SR - 700 American Boulevard
SCHEMATIC DESIGN | LAND USE APPLICATION

SR - 700 American
700 W AMERICAN BLVD / BLOOMINGTON, MN

PRELIMINARY
NOT FOR CONSTRUCTION
SCHEMATIC DESIGN
CITY SUBMITTAL
10.11.2023
REVISIONS

2 DETAIL - SHRUB PLANTING
1" = 1'-0" P-UR3-02

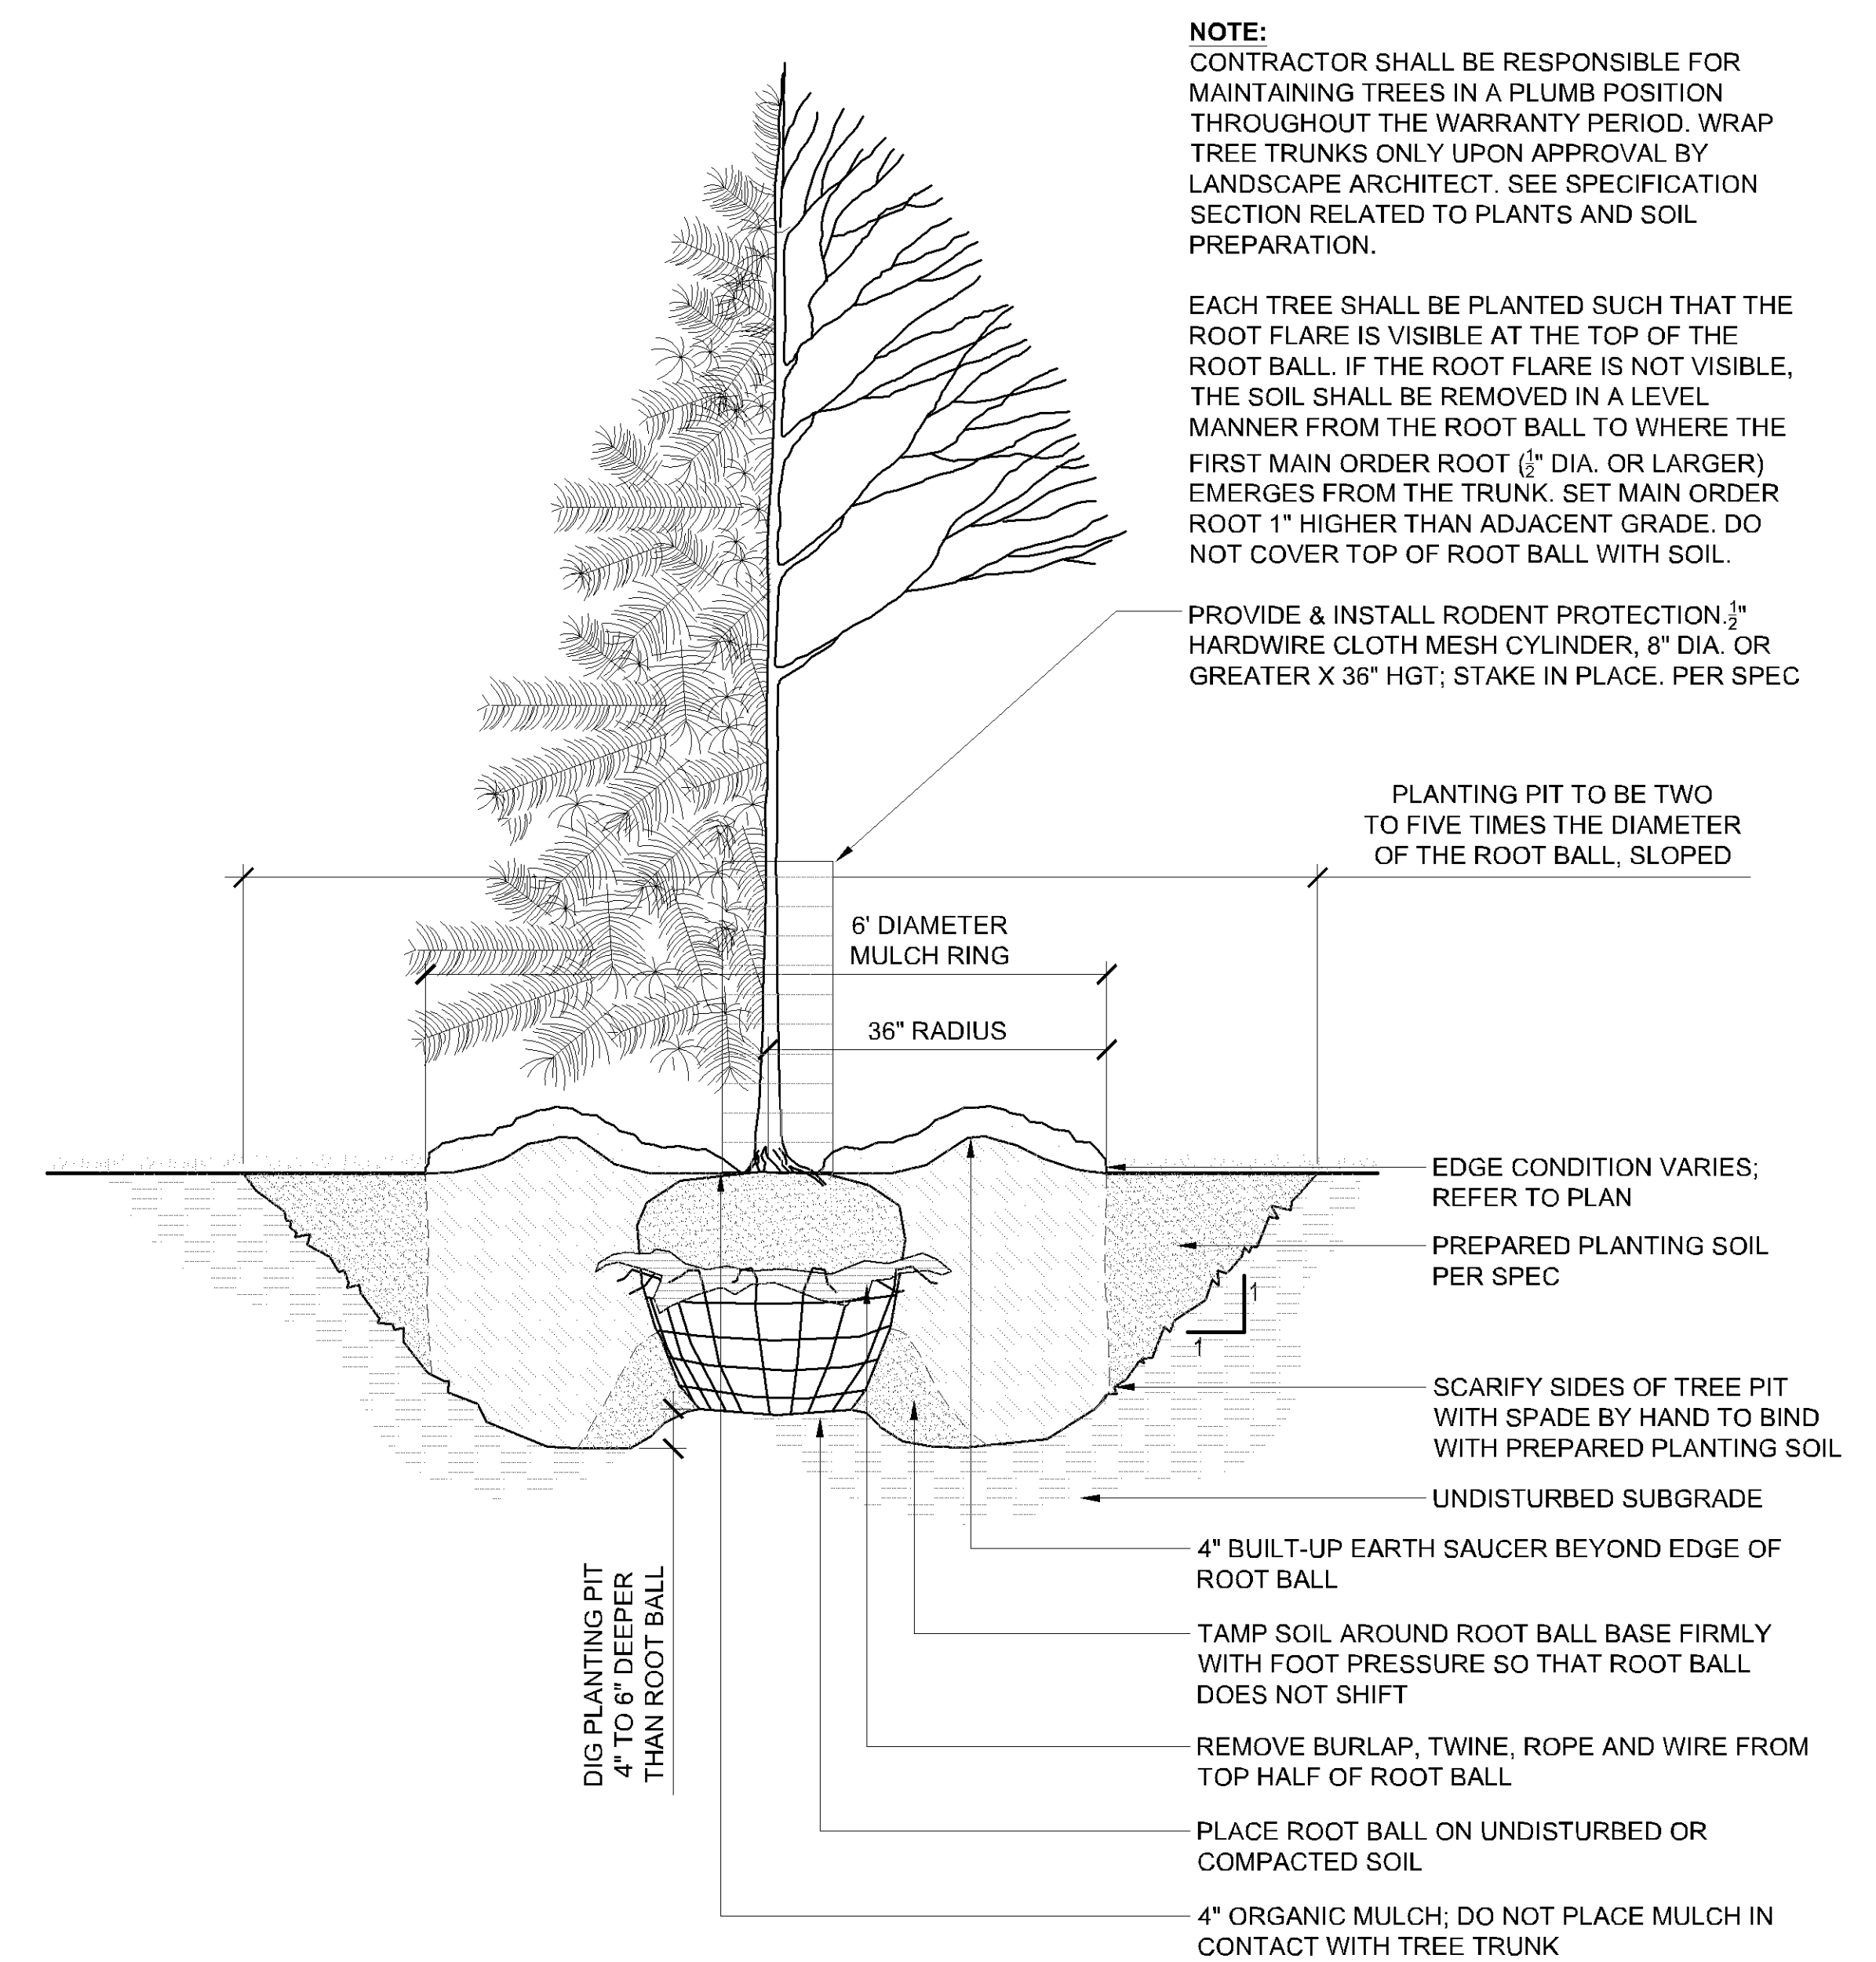
bike rack detail not included - Site plan references this sheet for bike rack detail
